MEMORANDUM

SUBJECT: Design Variation

RE: W.P.I. No. 1110874
State Project No. 05090-1511
Glades County

Subject: Response to Phase IV Review Comments
S.R. 29 at Bridge Nos. 050031, 32, 35, 941 in Glades County
Consultant: Genesis Group, Inc.
W.P.I. No. 1110874
State Project No. 05090-1511
Glades County

050941
032

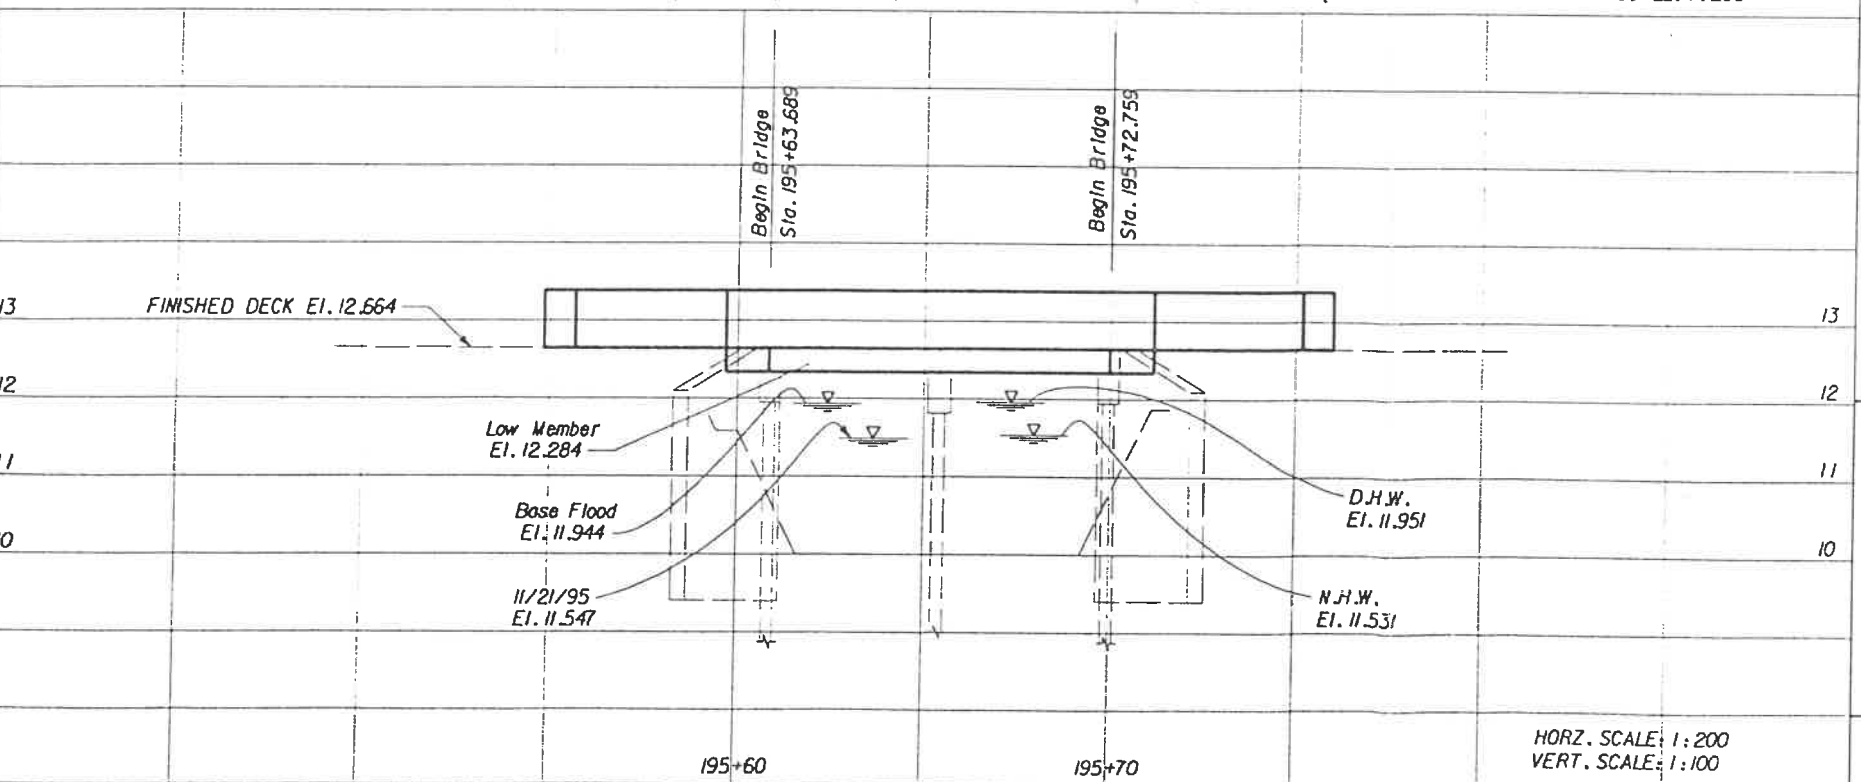
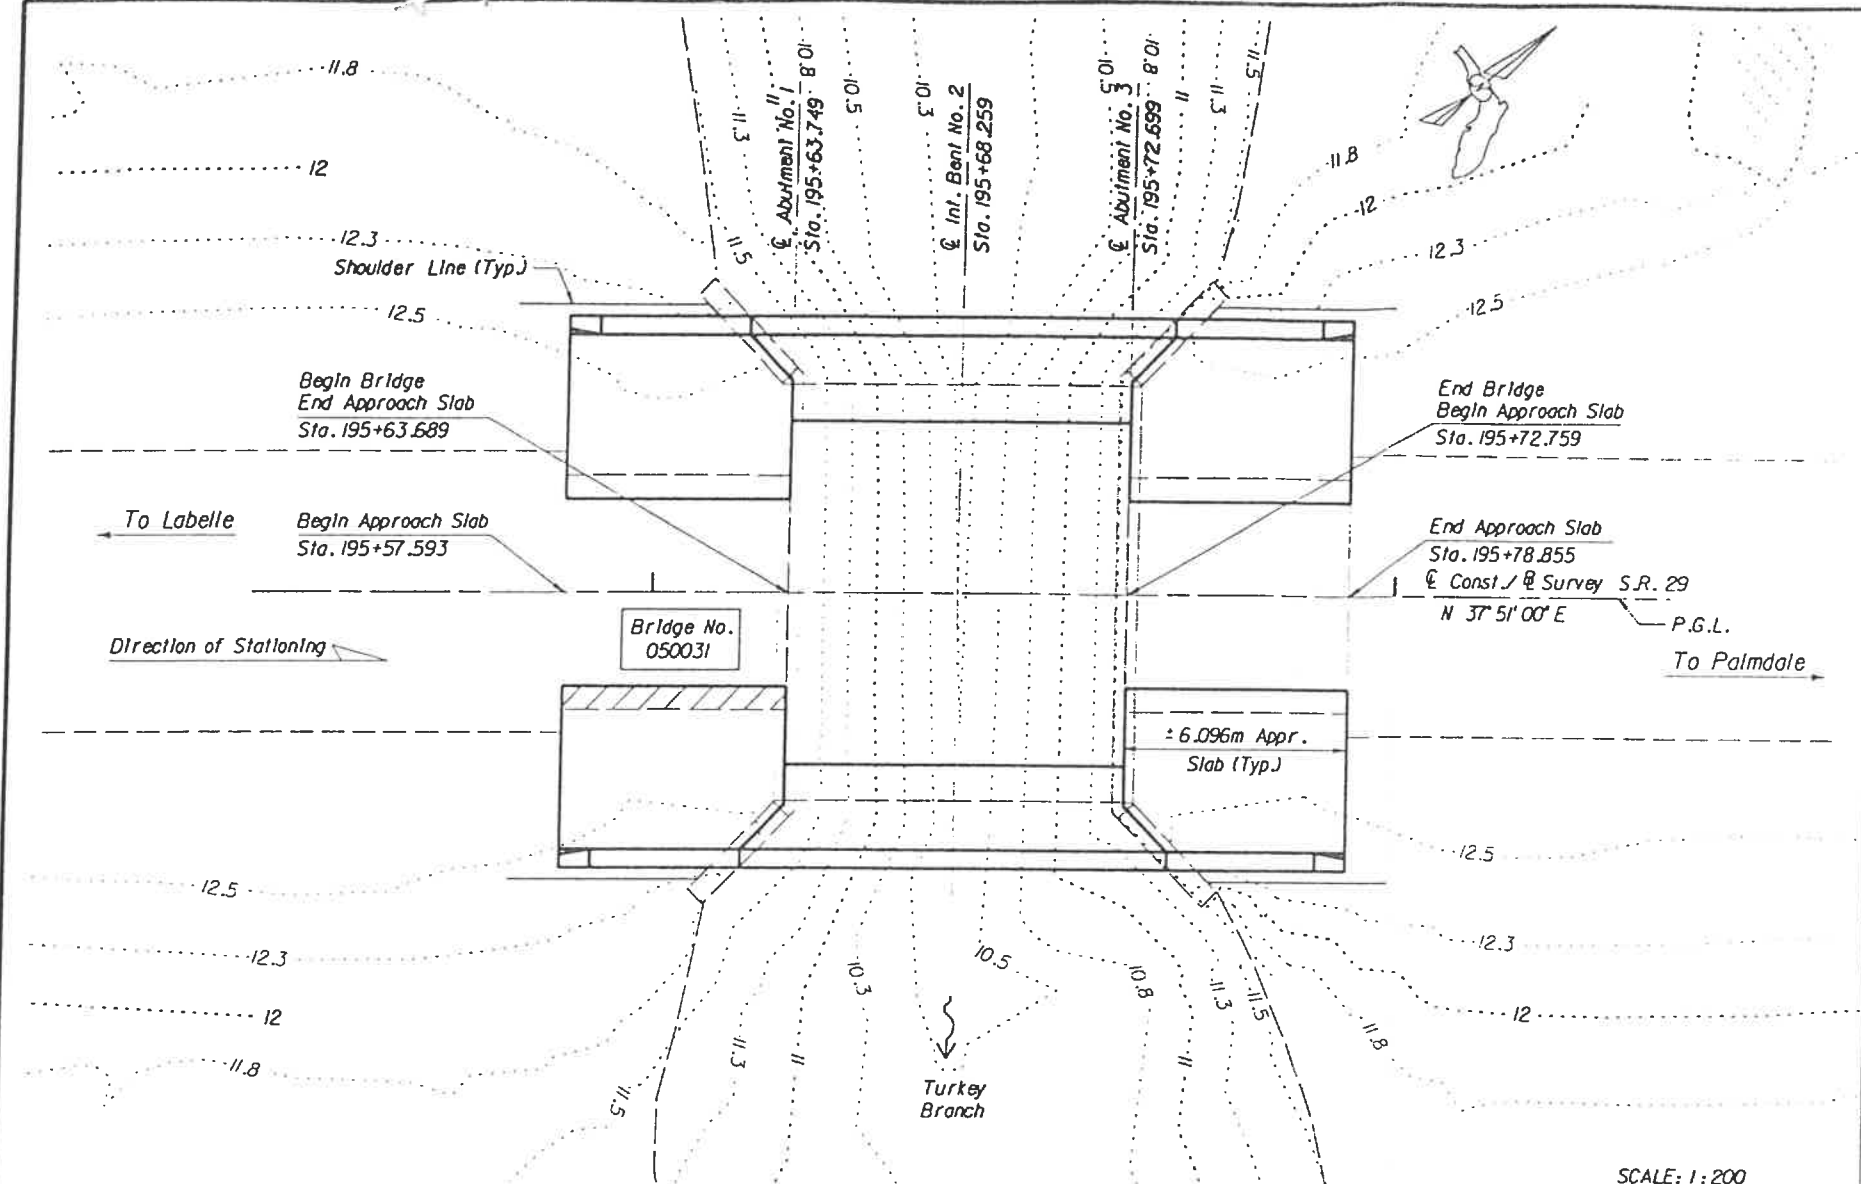
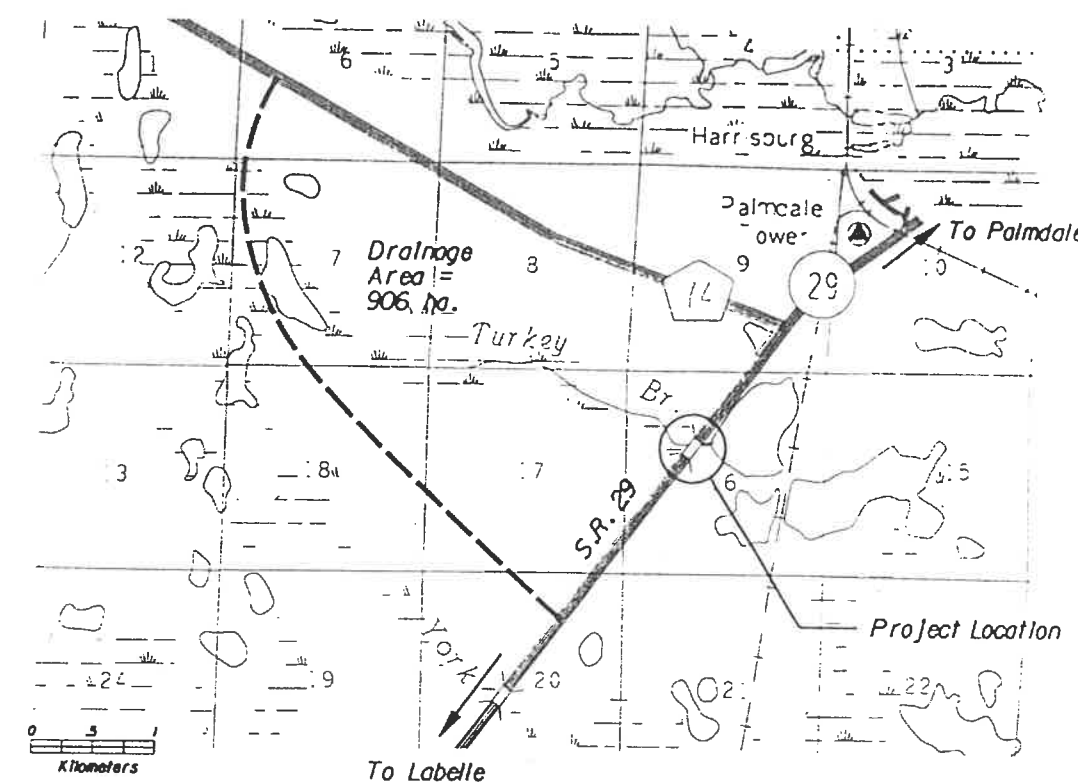
1. The approved BHRS states that the bridge deck will be drained via sheet flow. The Phase IV plans propose using scuppers. Typically scuppers are not allowed on bridges less than 120 meters. Please justify this change.

Response: We have modified the BHRS sheets to reflect "runoff will sheet flow off bridge into existing roadway drainage ditches" for Bridges 050035 & 050031.

- HYDRAULIC RECOMMENDATIONS**
- BEGIN BRIDGE STATION 195+63.689 END BRIDGE STATION 195+72.759 SKEW ANGLE 0
 - CHANNEL SECTION @ STATION 195+66.199 BOTTOM WIDTH 8.534 ELEV. 10.119 SIDE SLOPE 0
 - LIMITS OF CHANNEL EXCAVATION: RT. N/A LT. N/A
 - CLEARANCE: NAVIGATION: HORIZ. N/A VERT. N/A ABOVE EL. N/A DRIFT: HORIZ. 3.962 VERT. 0.333 ABOVE EL. 11.951
 - SCOUR PREDICTION: 100 YEAR DESIGN SCOUR EL. 7.95 DEPTH = 7.12
500 YEAR SCOUR EL. 7.79 DEPTH = 9.61
 - SLOPE PROTECTION: None
 - DECK DRAINAGE: Runoff will sheet flow off bridge into existing roadway drainage ditches.
 - OTHER:

FIGURE 7
 SURVEY CROSS SECTIONS
 USED FOR WSPRO ANALYSIS

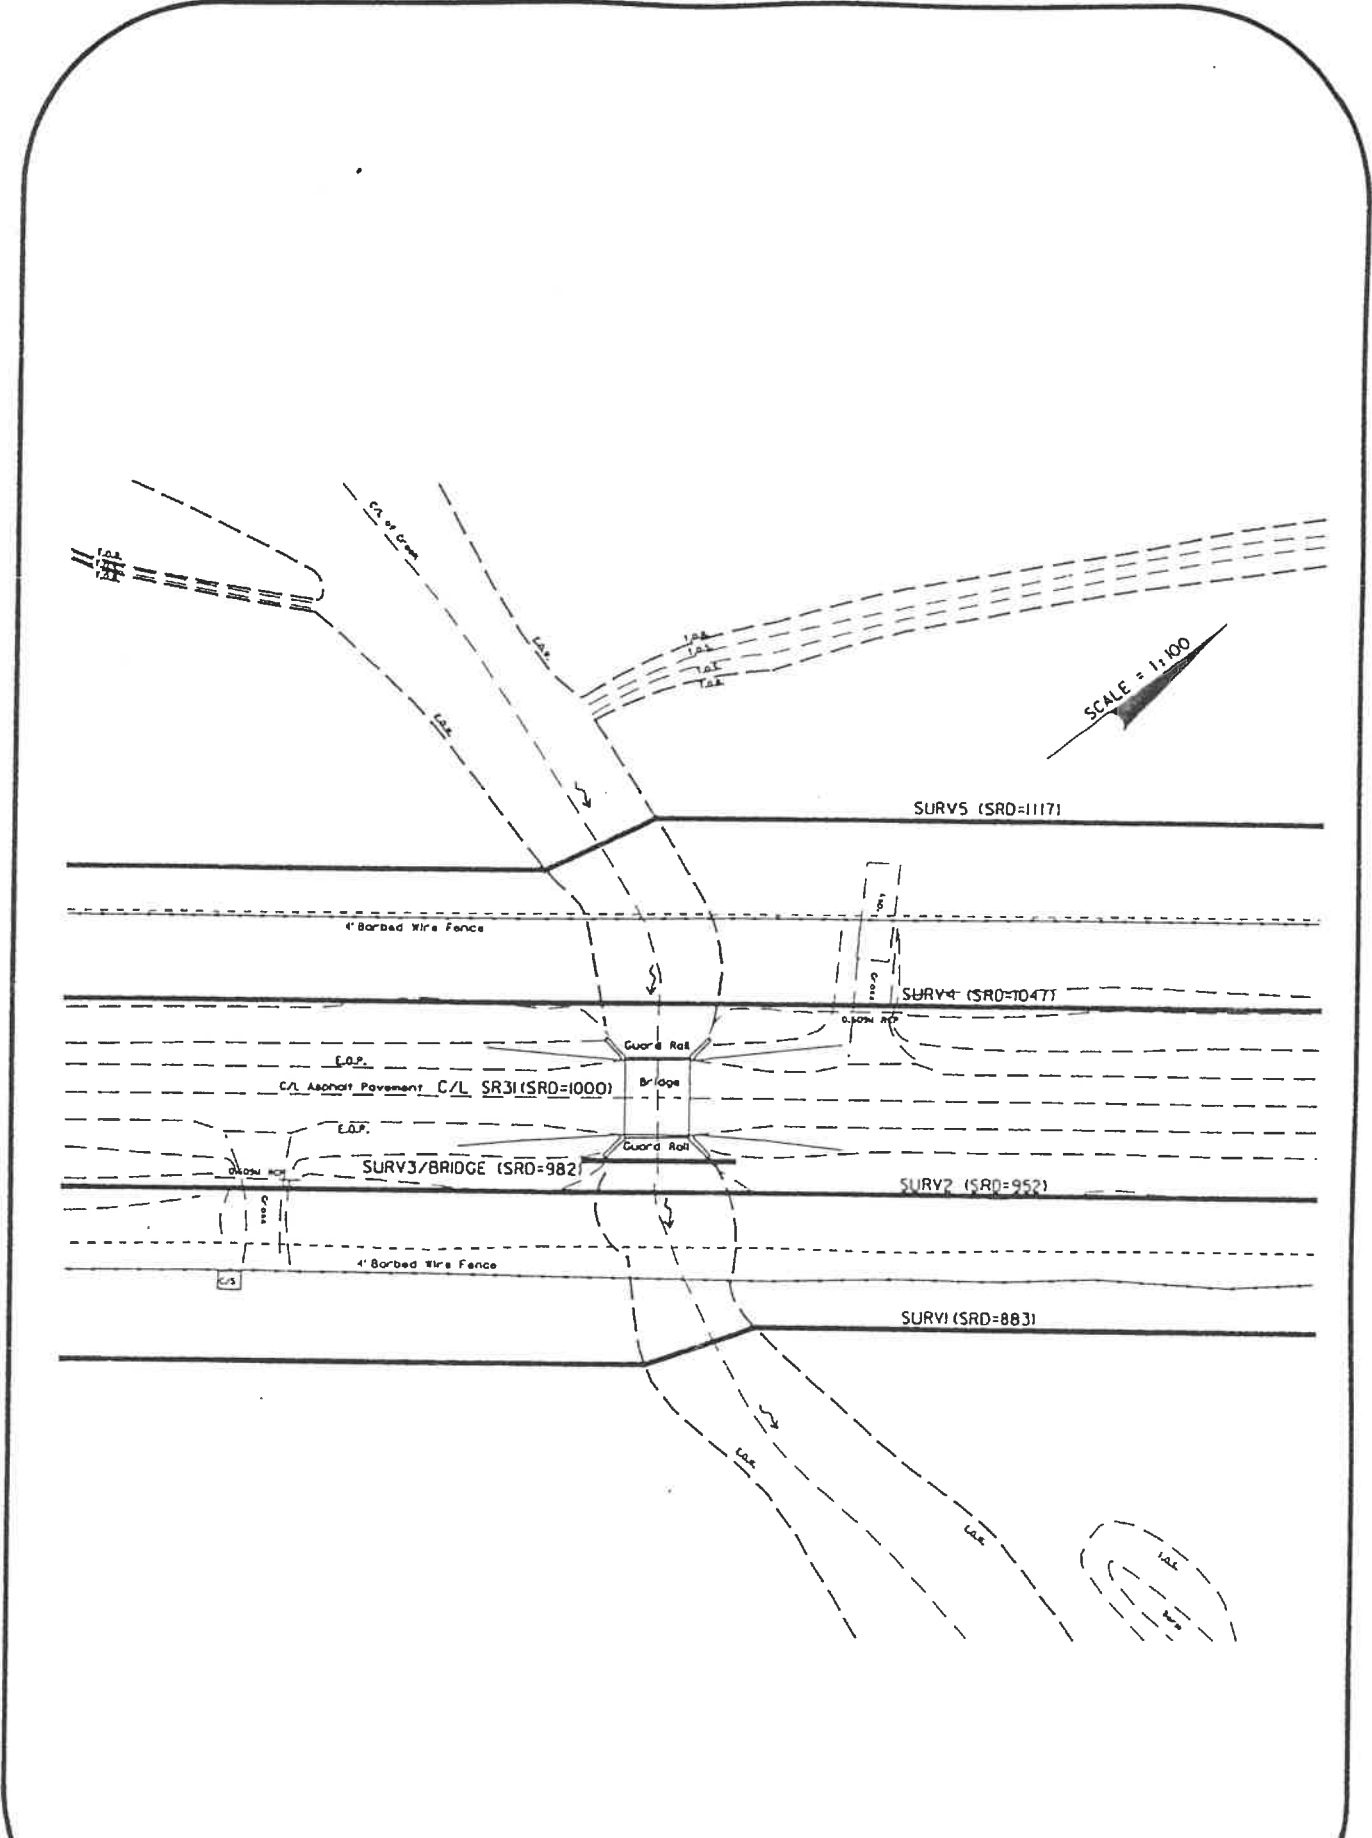
9. Please clarify the last sentence on Page 11, it is not very clear.
10. Figure 7 shows two Approach Sections. Please change the correct one to "Exit Section".

- should fig. 3 show ^{exit} app instead of approach on downstream side? (p 15)
- Table 3 title is on following page (pp 16 & 17)
 one page is out of order

RESPONSE: So noted and corrected.
